<b>Licence Number</b>	L8621/2011/1
<b>Licensee</b>	Roy Hill Iron Ore Pty Ltd
<b>ACN</b>	123 722 038
<b>File Number</b>	2011/009784
<b>Premises</b>	Roy Hill Iron Ore Mine M46/518 and M46/519 NEWMAN WA 6753
<b>Prescribed Premises</b>	Category 5 – Processing or beneficiation of metallic or non-metallic ore Category 6 – Mine dewatering Category 12 – Screening, etc. of material Category 54 – Sewage Facility Category 52 - Electric power generation Category 57 – Used tyre storage (general) Category 64 – Class II putrescible landfill site Category 73 – Bulk storage of chemicals, etc.
<b>Date of Amendment</b>	31/05/2018

#### **Amendment**

This amendment is made pursuant to section 59 of the *Environmental Protection Act 1986* (EP Act) to amend the Licence issued under the EP Act for a prescribed premises as set out below. This notice of amendment is given under section 59B(9) of the EP Act and is limited only to an amendment for Category 5; to install and operate Tailings Storage Facility (TSF) evaporators.

**Figure 1: Location of evaporators within the Premises boundary.**

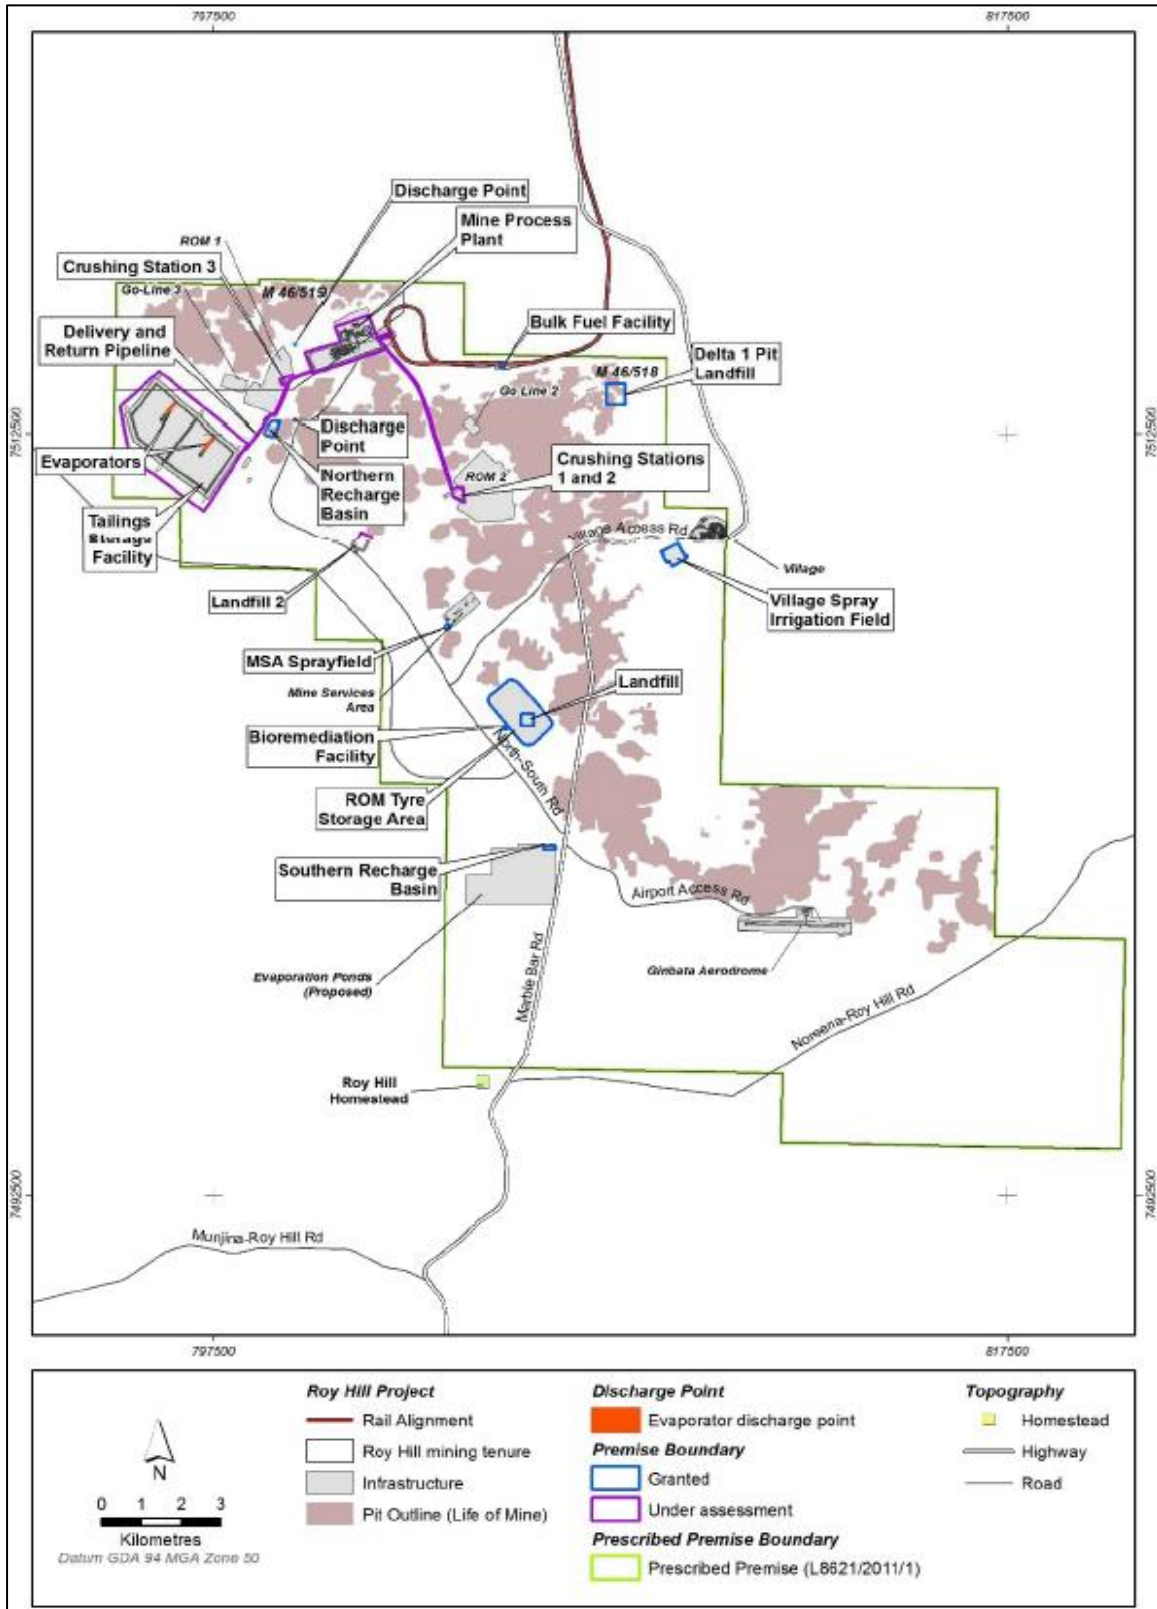
This new amendment application is requesting approval to construct and operate an additional seven 90kW evaporators on Cell 2 of the TSF, with the original seven Minetek 75kW evaporators remaining on Cell 1 (14 evaporator units in total). The Licensee proposes to install the new evaporators units with the same configuration and location (internal causeway) as the existing evaporators. The power to the seven evaporators on Cell 2 will be supplied by four 220KVA diesel generators with 1,000L tank capacity and 110% double banded base to capture spillage from tank failure. The generators will be located on the decant causeway and will be refilled regularly by fuel truck. The generator fill points will have spill collection installed and spill kits will be located at each generator.

The location of the evaporators (highlighted in orange) is also depicted in Figure 1 below, and in greater detail in Figure 2 (yellow dots).

Figure 2: Location of evaporators within the TSF.

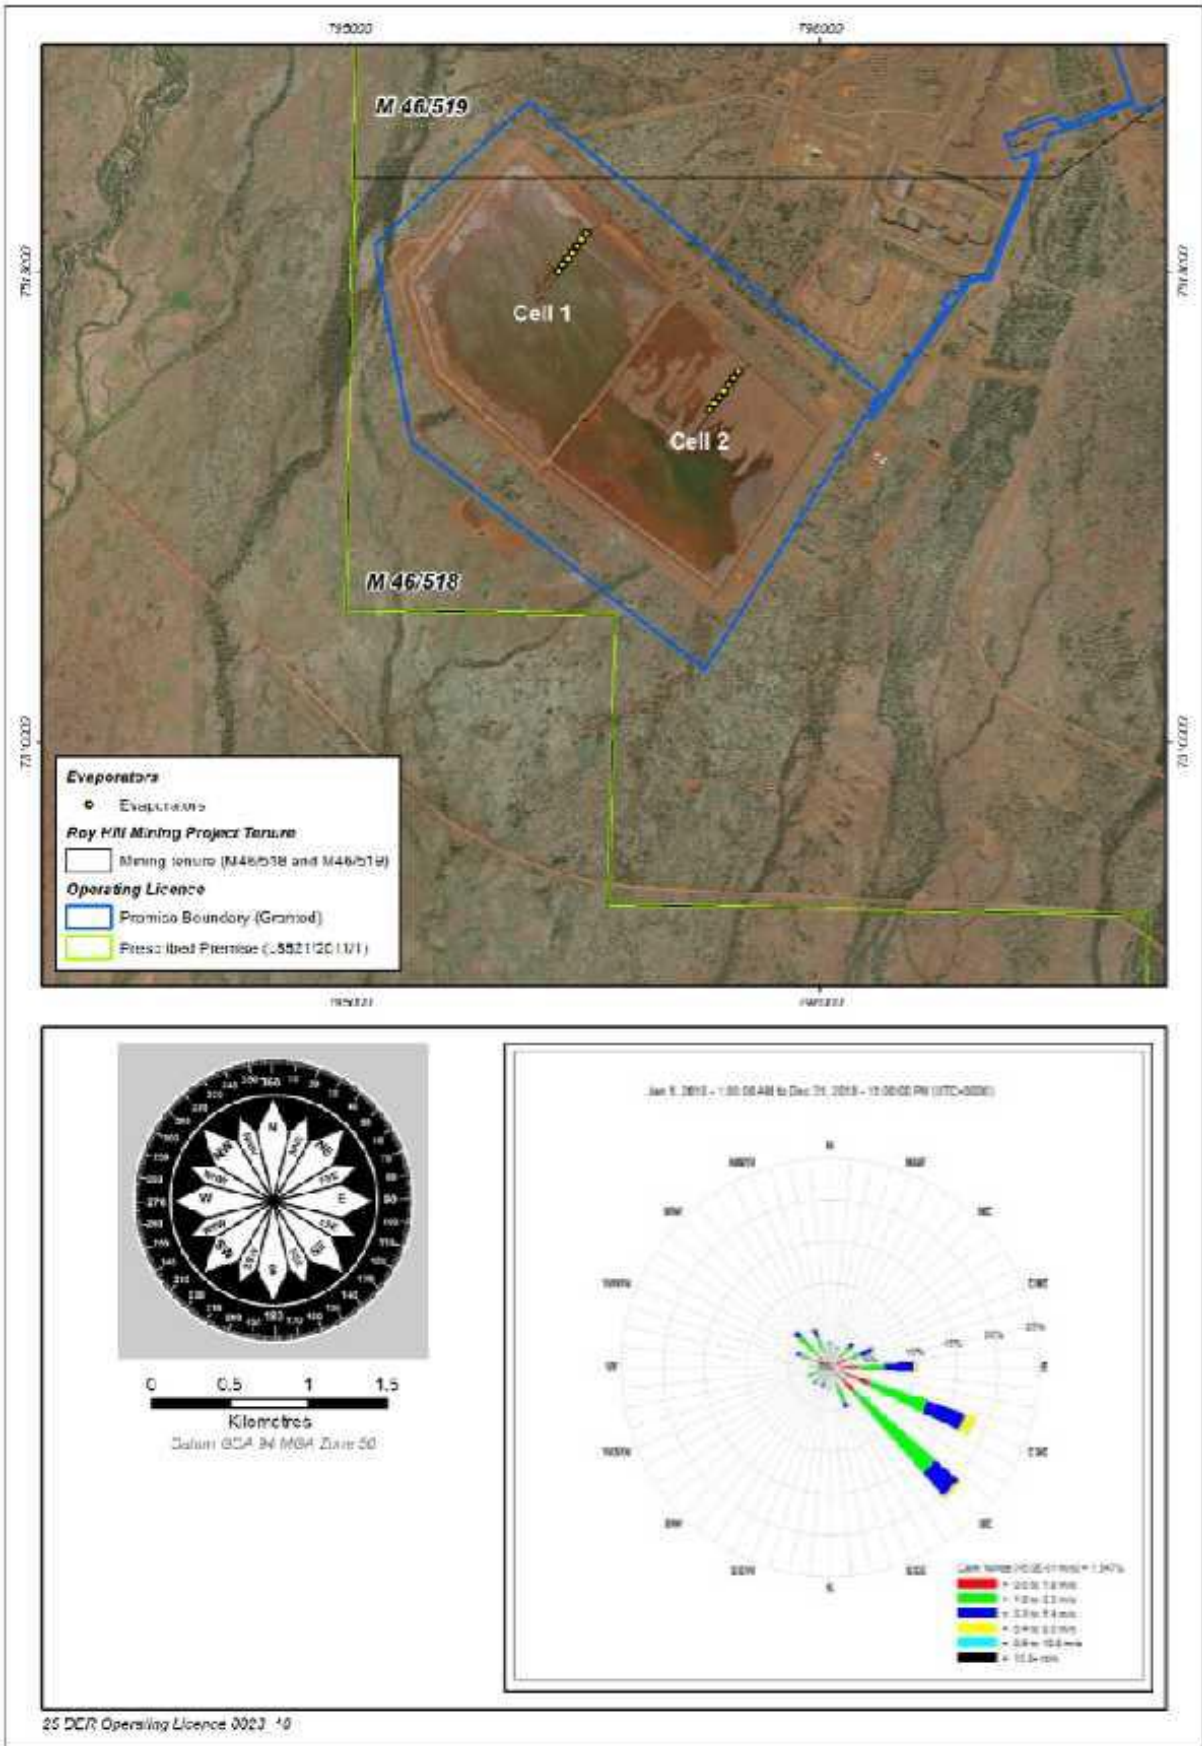
Description	Figure	Reference	Easting	Northing
Evaporators in TSF Cell 1	2	1	796510.92	7513248.99
		2	796480.63	7513208.26
		3	796451.39	7513168.58
		4	796421.10	7513127.84
		5	796391.86	7513087.63
		6	796361.05	7513047.43
		7	796331.28	7513007.74
Evaporators in TSF Cell 2	2	1	797478.86	7512365.57
		2	797448.57	7512324.84
		3	797419.33	7512285.16
		4	797389.04	7512244.42
		5	797359.80	7512204.21
		6	797328.99	7512164.01
		7	797299.23	7512124.32
